Planning Commission Staff Report

Subject: King's Crown
Author: Francisco Astorga, AICP, Senior Planner
Project #: PL-17-03515, PL-17-03566, & PL-17-03567
Date: 29 November 2017
Type of Item: Master Planned Development, Conditional Use Permit, and Re-Subdivision

PRELIMINARY UTILITY PLAN
KING'S CROWN

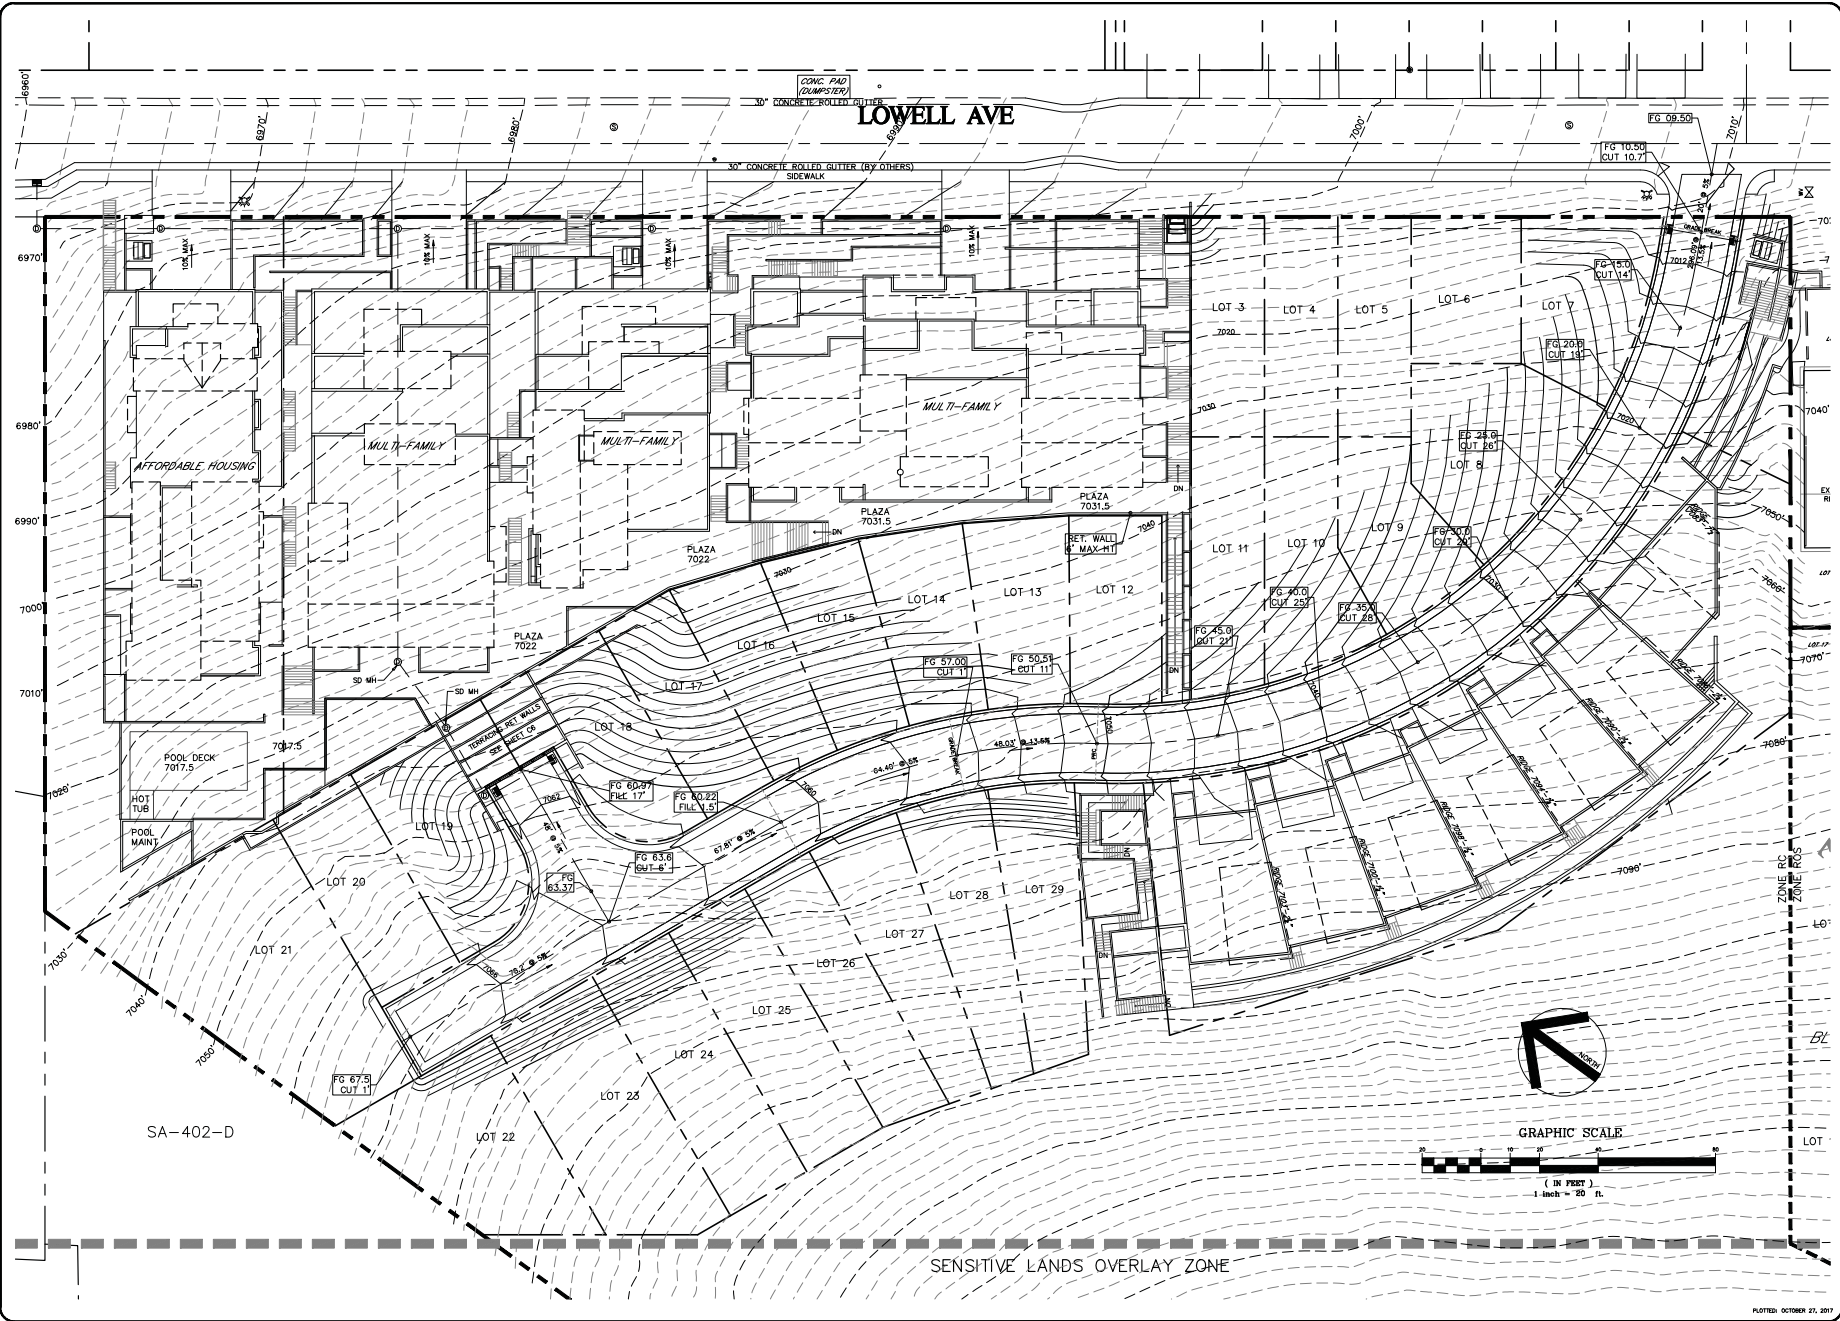
- New water lateral lines to be extended from the future water main.
 - Fire (water) line size not yet determined (may not be a 4" line).
 - Plan to show off-site improvements/connection at the MountainSide (bore cross driveway).

- One (1) master water meter preferred at each multi-unit building (able to set up individual meters after master meter).
- Storm Drain
 - Rip rap lined ditch concerns with overflow. Storm drain has to be piped as it affects properties to the north.

- Do not suggest/recommend placing storm water detentions along the front yard areas. Are there other opportunities for other locations?
 - Calculations needed for the entire storm water/shed system, impacts of the site pre and post development to determine flows, capacity, volumes, etc.

- Sewer
 - Please check with the Snyderville Basin Water Reclamation District as a Line Extension Agreement (LEA) may need to be filed with them in order for them to provide a full analysis of your proposed sewer (utility) plan. The District is a review/signing entity on the plat.

- Concerned with the water main line and sewer line crossing on Kings Crown Drive. May need more sewer man-holes to avoid the crossing. Can the sewer line be accommodated on the downhill side and the water on the uphill side?

- No sewer lateral shown on Lot 16
- Power
 - Conflict with the proposed buried location on the west side of Lowell Avenue as it is adjacent to the water main line. The gas and water lines were designed to co-exist in this location, however, the proposed power line is too close to the water line. Buried power has to be at least 10' from the edge of main water lines.

RETAINING WALL PLAN
AS-011

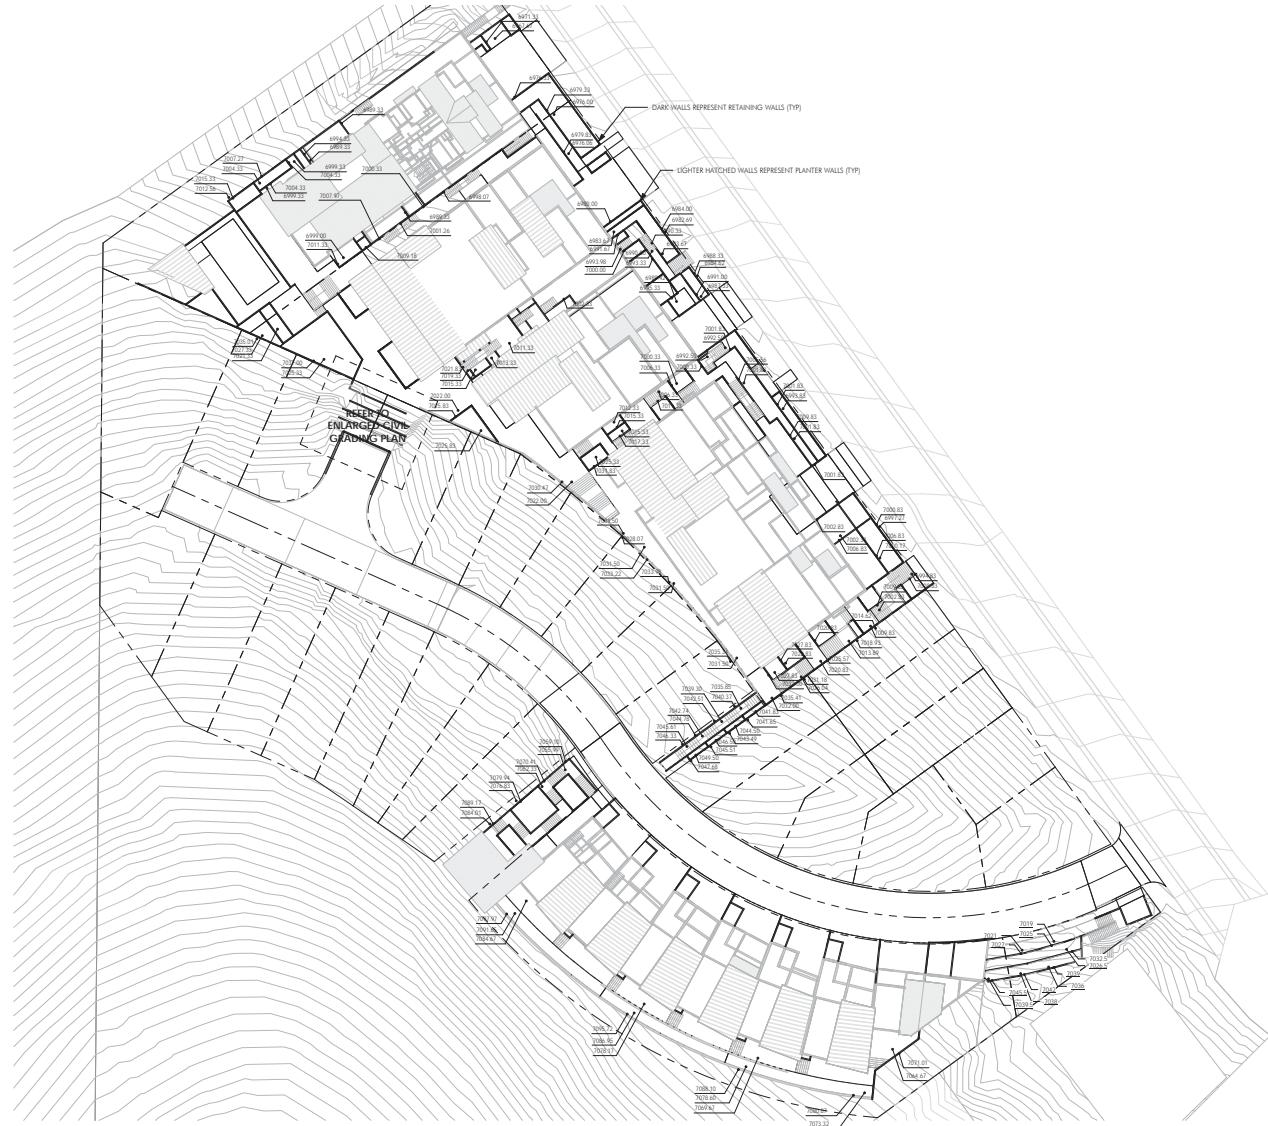
- Retaining walls heights are measured from final grade. Need heights of the retaining walls around and adjacent to the multi-unit dwellings.
 - Can the retaining feature/planter adjacent to the 7 townhouses box be extended to the front property line to break up the massing of each adjacent driveway?
